ROOF REPLACEMENT CAPITAL PLAZA

FRANKFORT, KENTUCKY

REVISION NO. 1 11 APR. 2005

"AS-BUILT" NOTE:

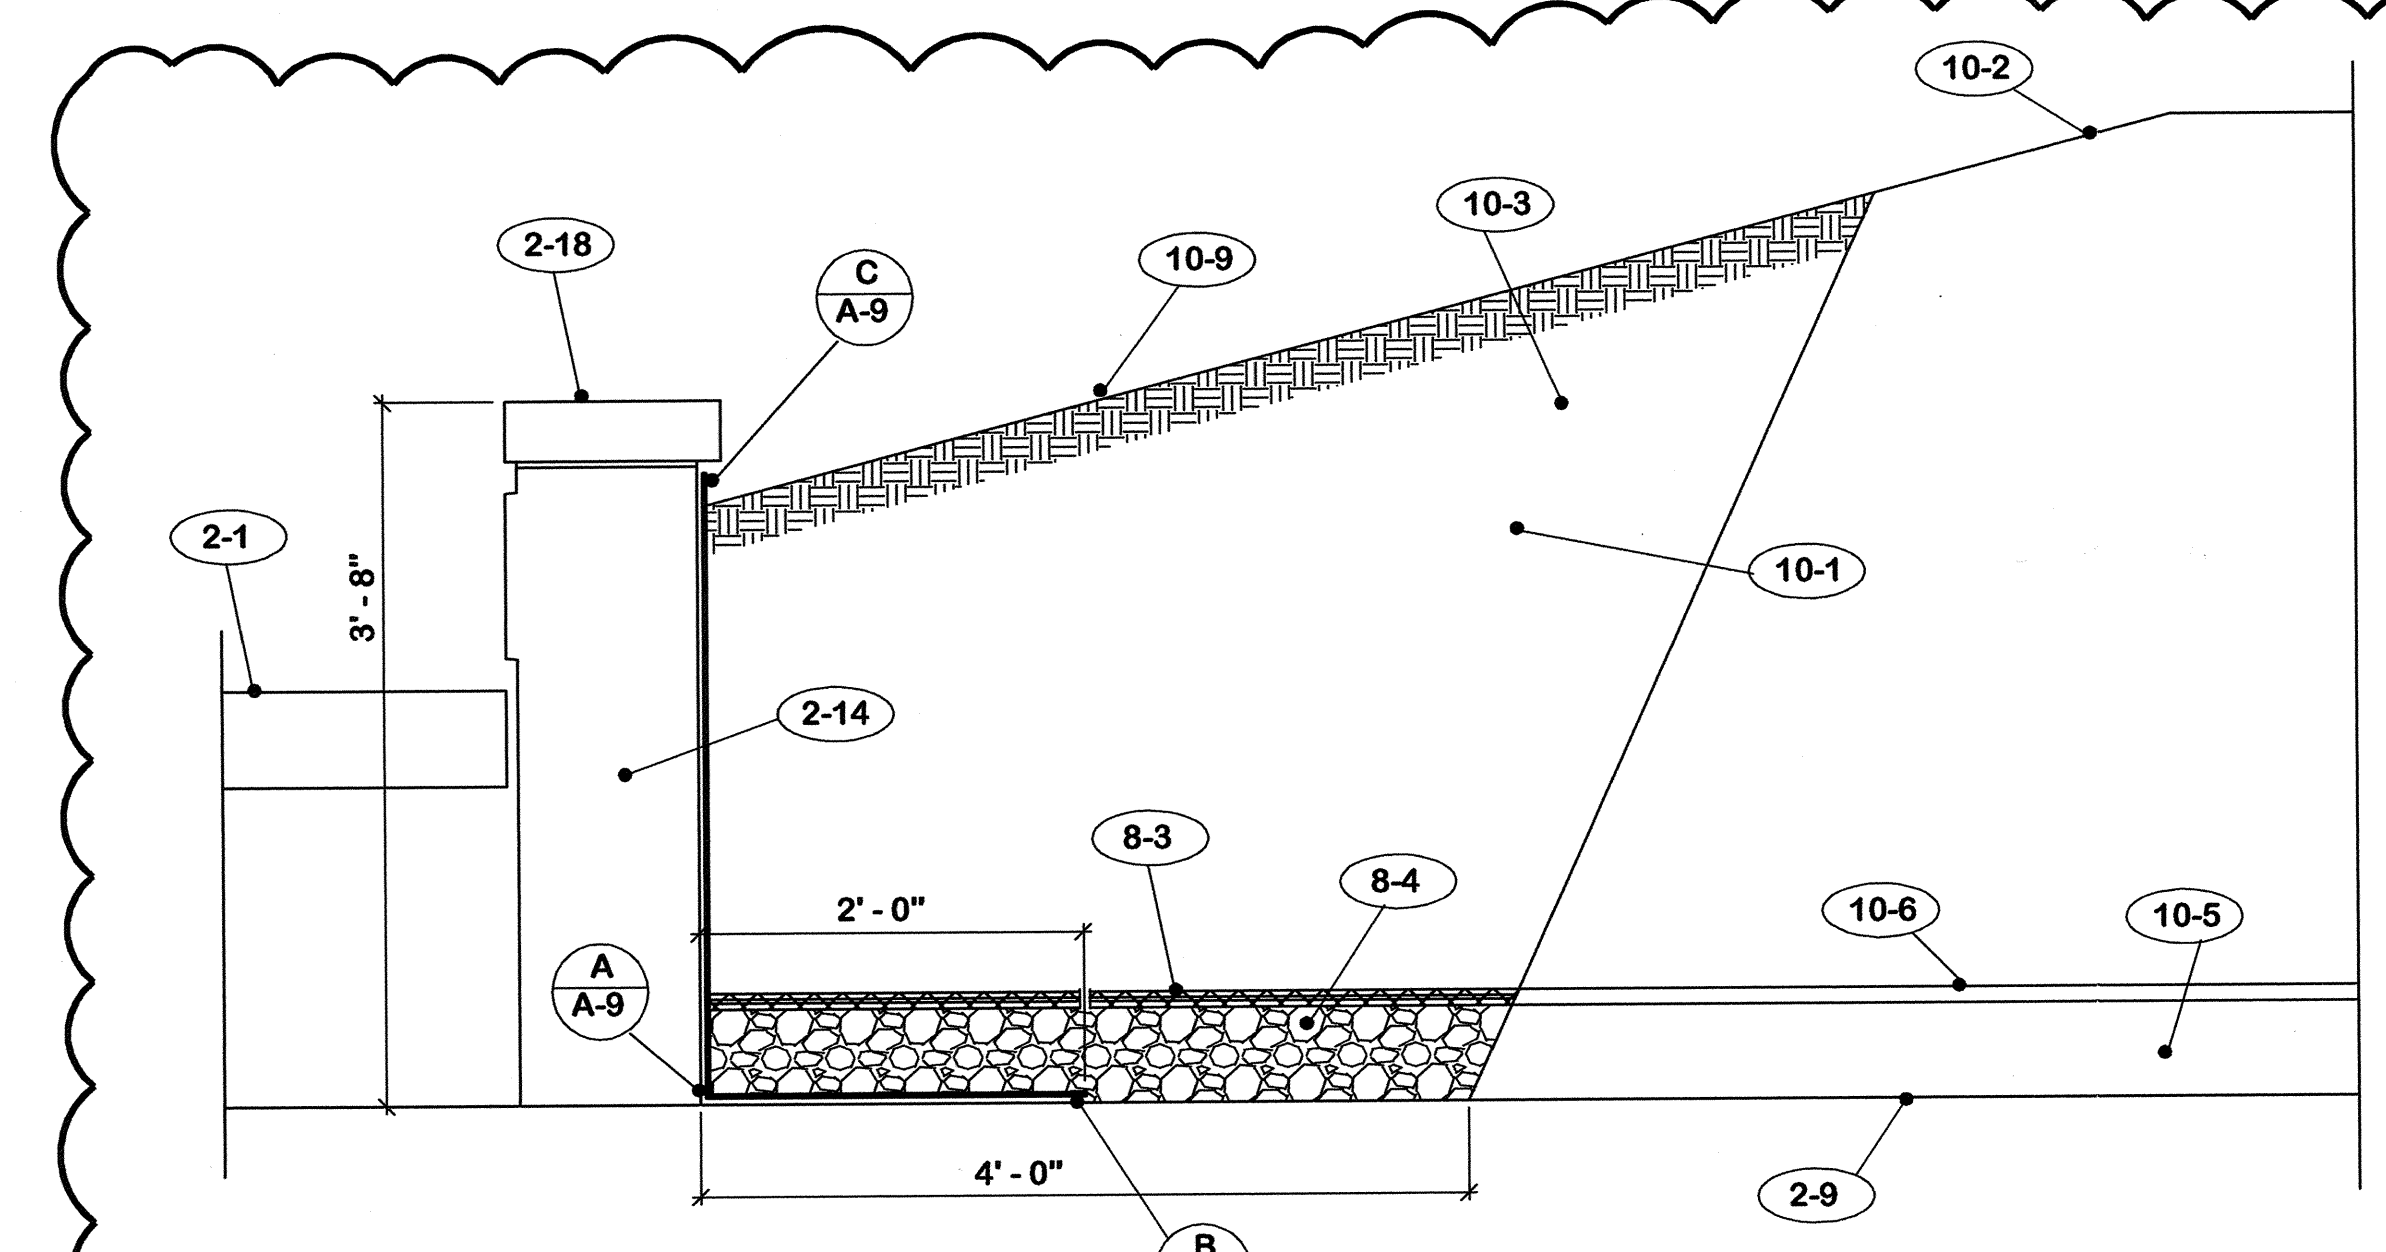
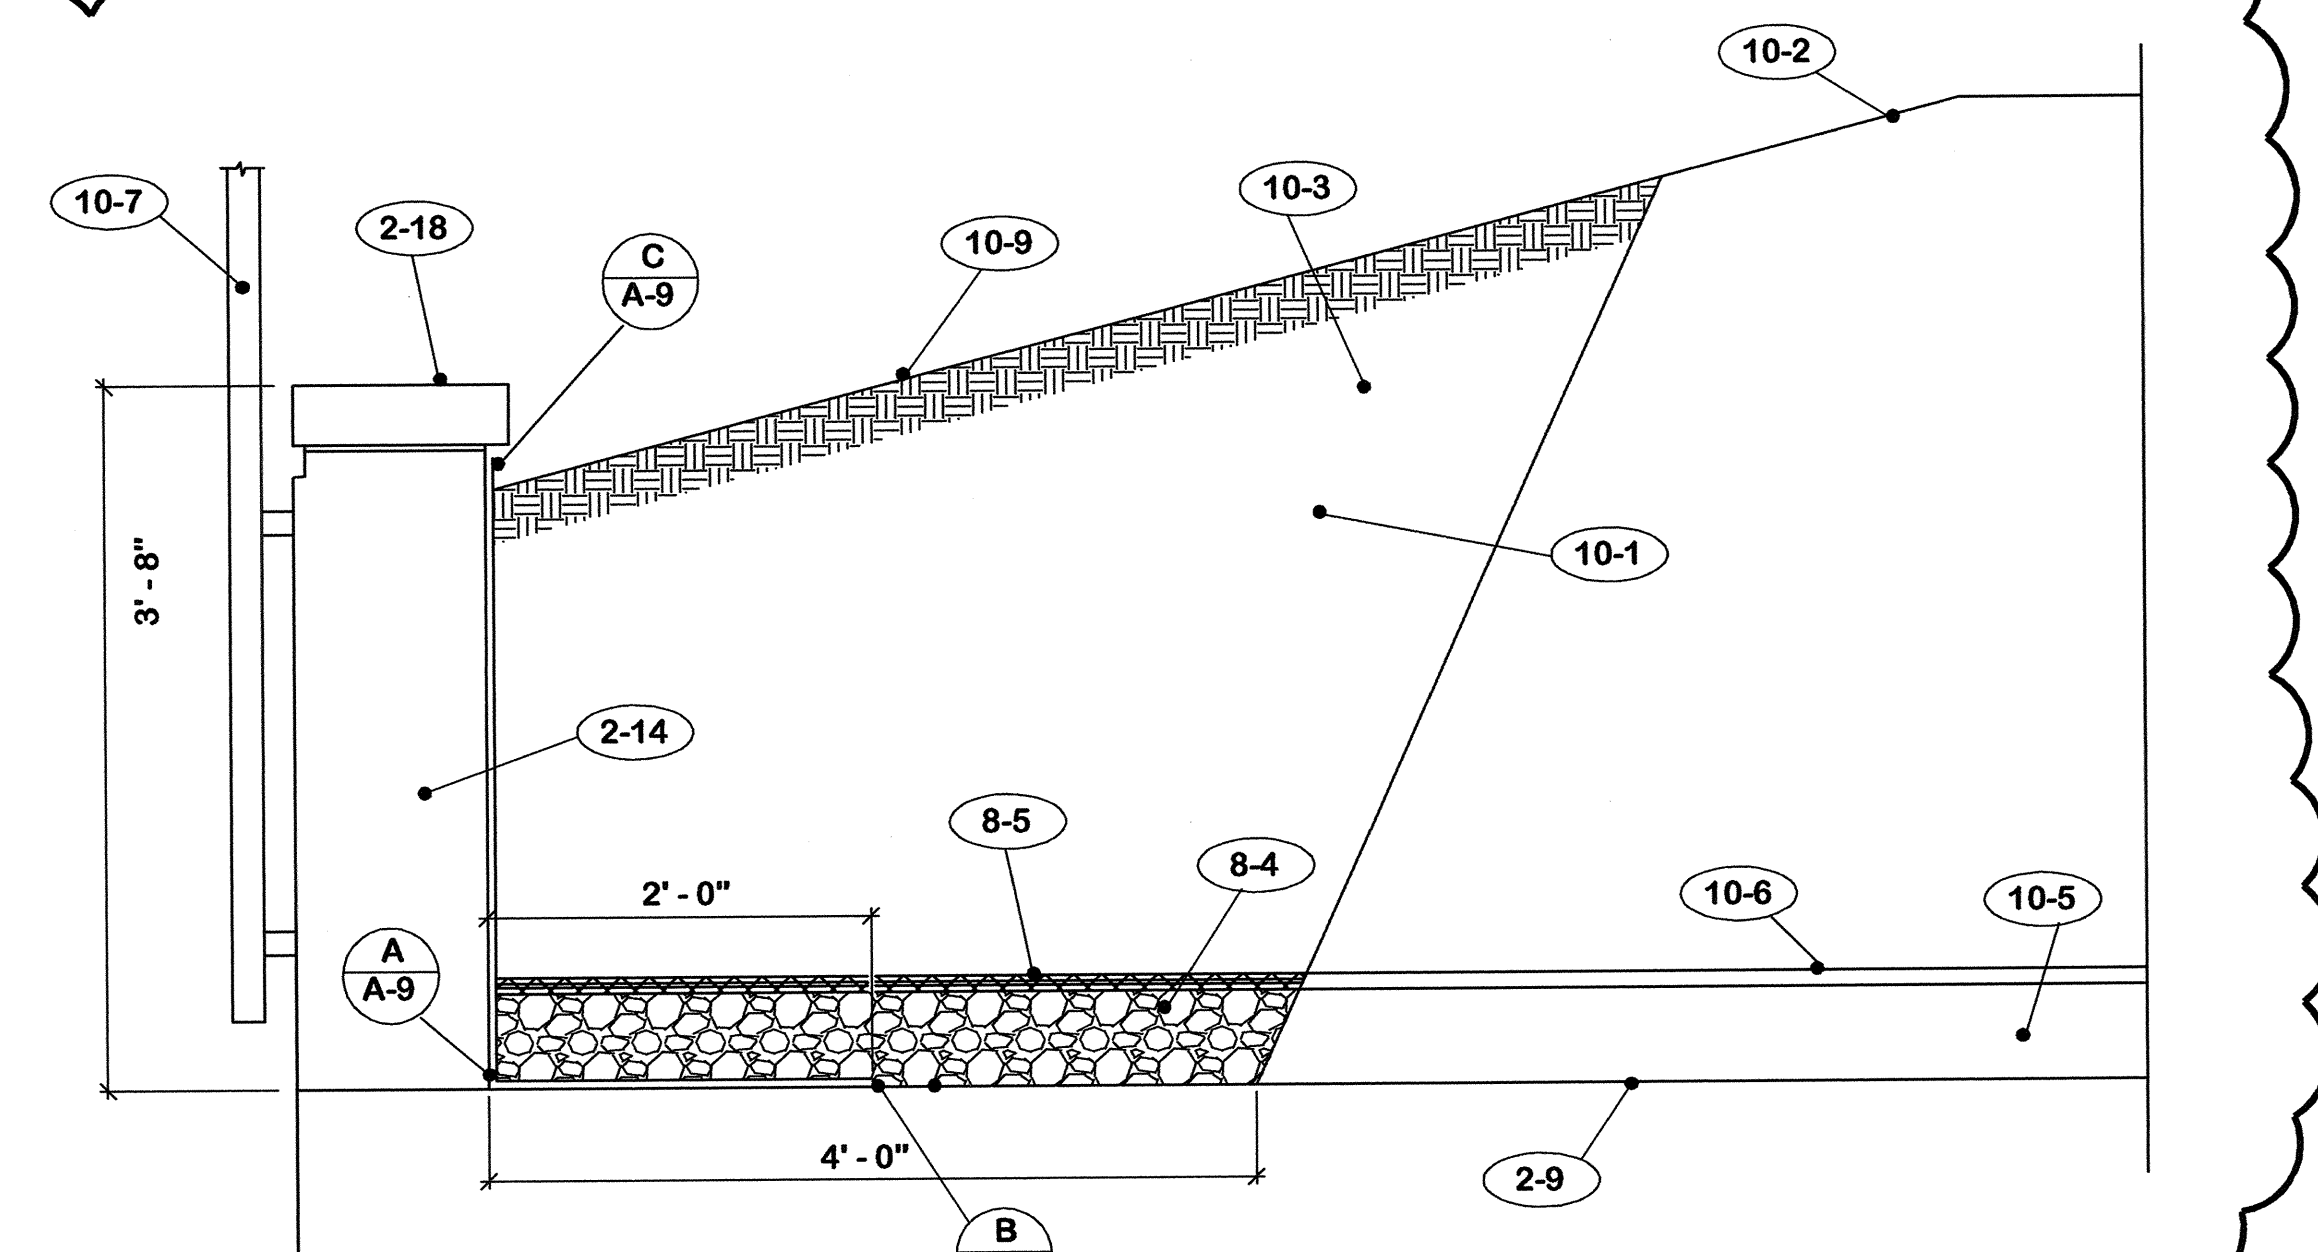
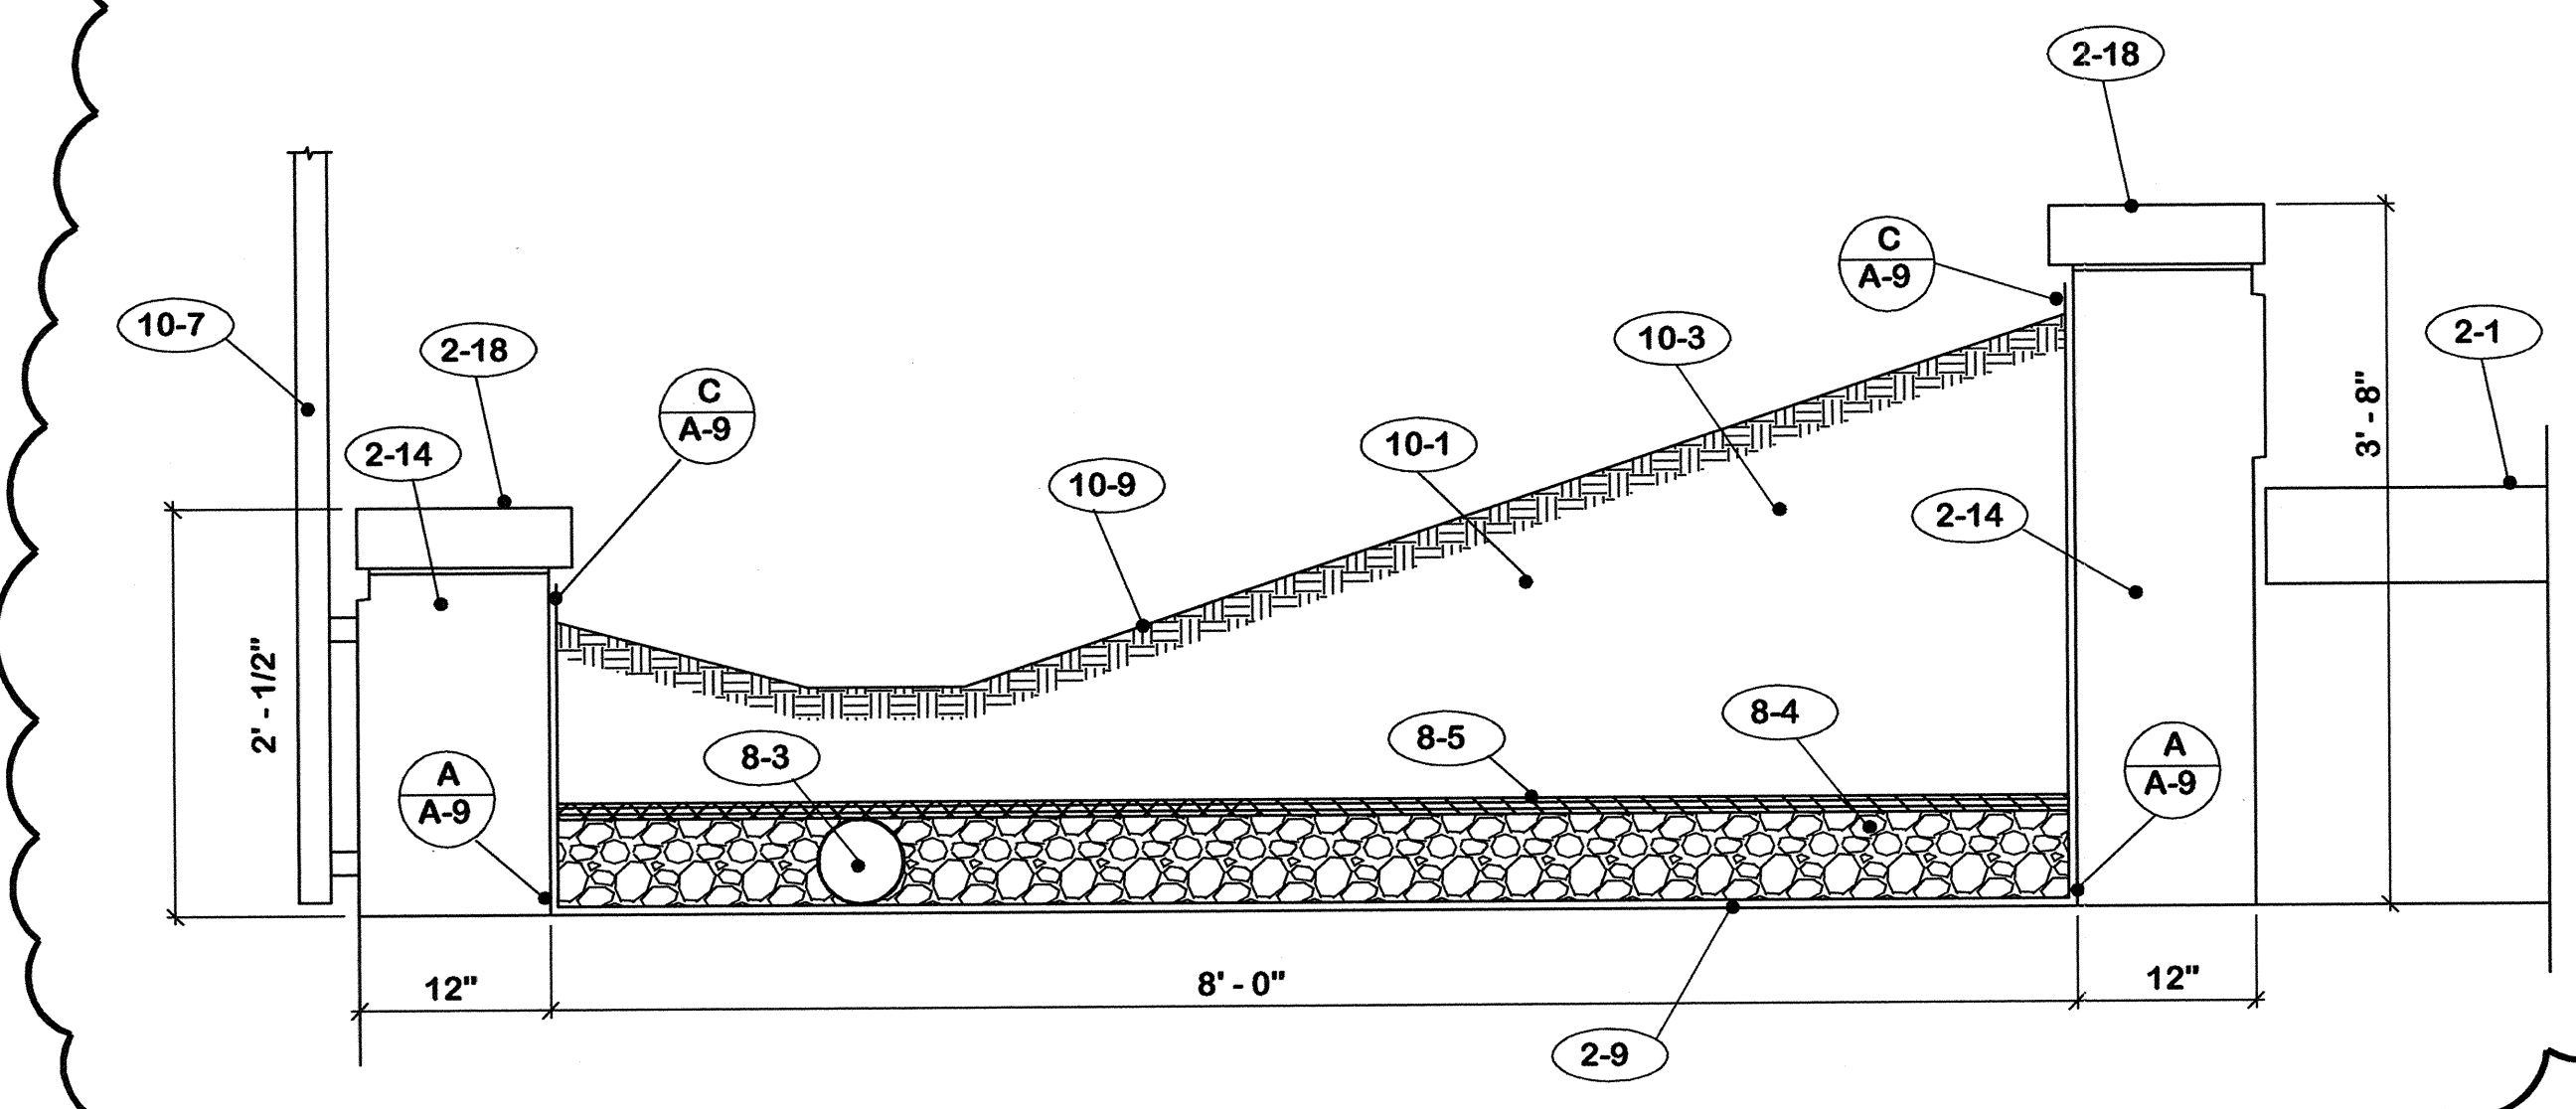
"AS-BUILT" NOTE:
1. Delete Sections C/A-12, D/A-12 and E/A-12
